Project	PWM Terminal Enhancement	Project Number	09.6395.000
Description	CBRA Room ETD Revised Location	Issue/Rev	Bulletin 109/122
Prepared by	BNP ASSOCIATES	Date	06/06/11
Scale	1/2"=1'-0"

**C** DETAIL SECTION AT CBRA  
 B03.01.01 1/2" = 1'-0"  
 FINAL HEIGHTS TO BE ADJUSTABLE  
 AND COORDINATED WITH L3 AND THE  
 LOCAL TSA.

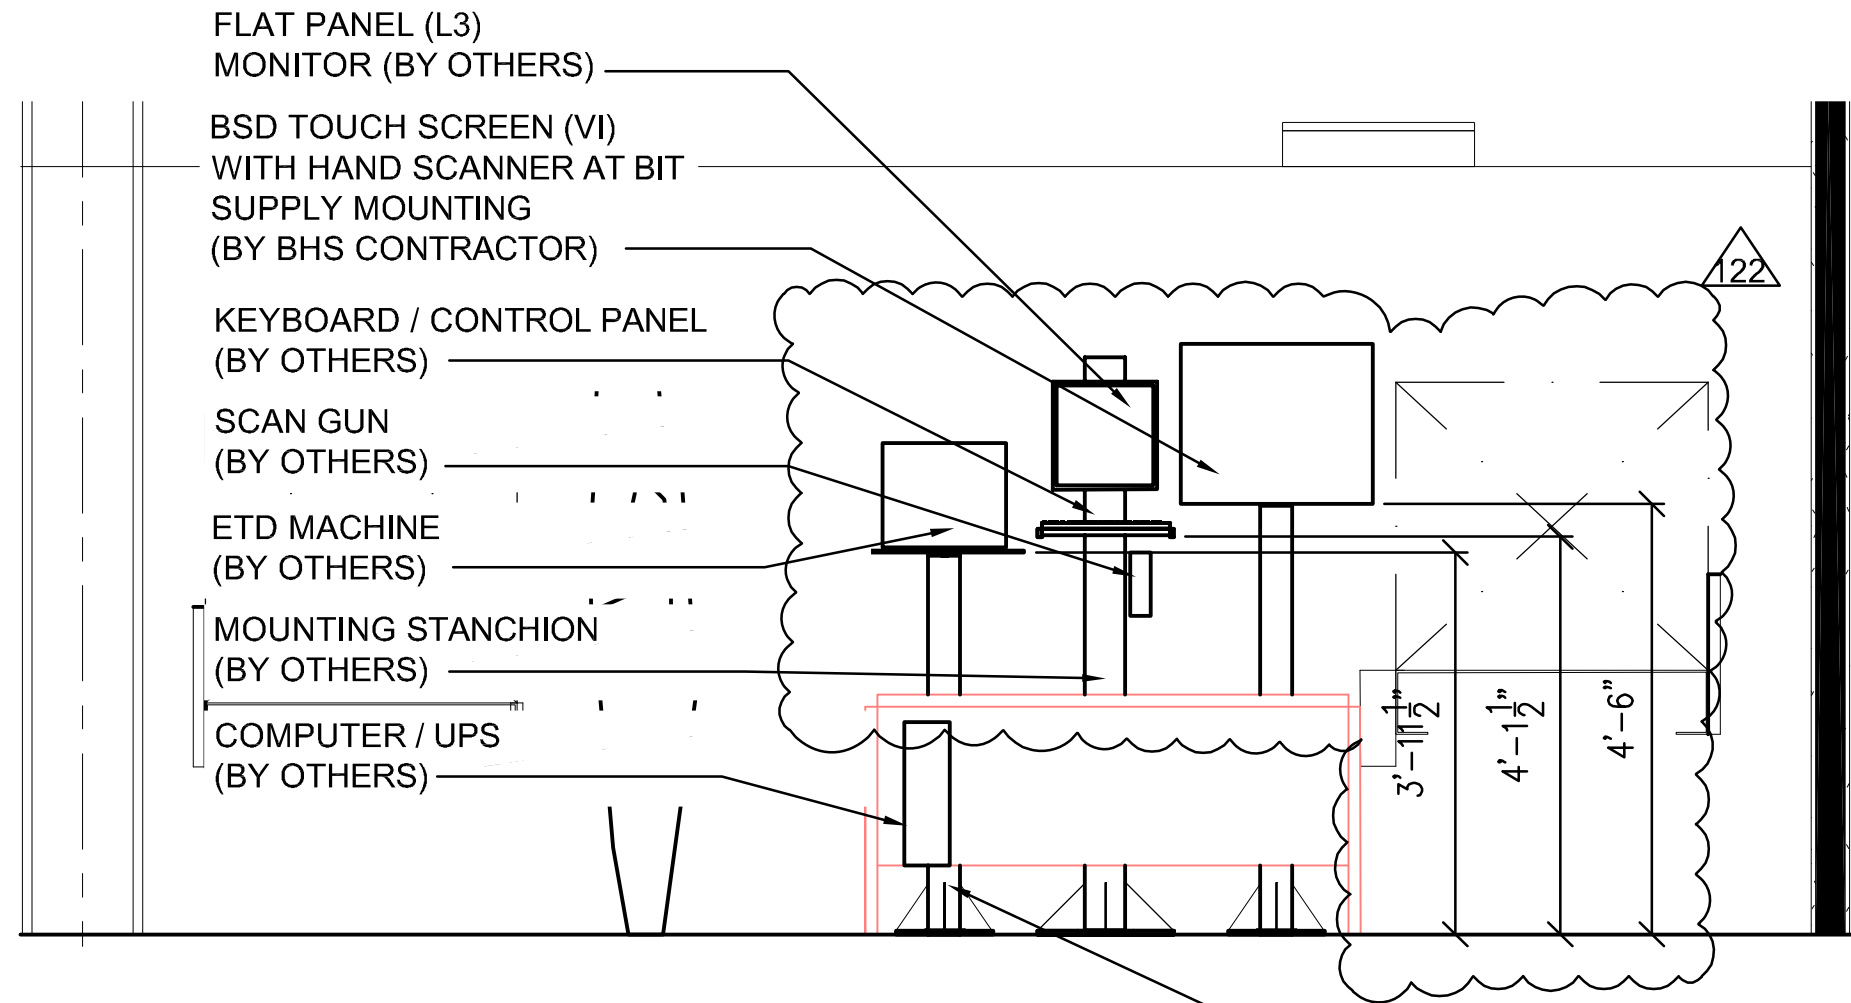
PROVIDE ETD SUPPORT BASE  
 WITH STANCHION AND COORDINATE  
 SIZE ALONG WITH RETAINING EDGE  
 ON ALL SIDES WITH ETD UNIT;  
 ETD UNIT TO BE PROVIDED BY TSA.  
 FINAL HEIGHT TO BE ADJUSTABLE AND  
 COORDINATED WITH LOCAL TSA.

PER TSA DIRECTION SUPPLY LUCASEY  
 PART # TSAP4800 PEDESTAL AND  
 ETD TRAY. SEE ATTACHED CUT SHEET
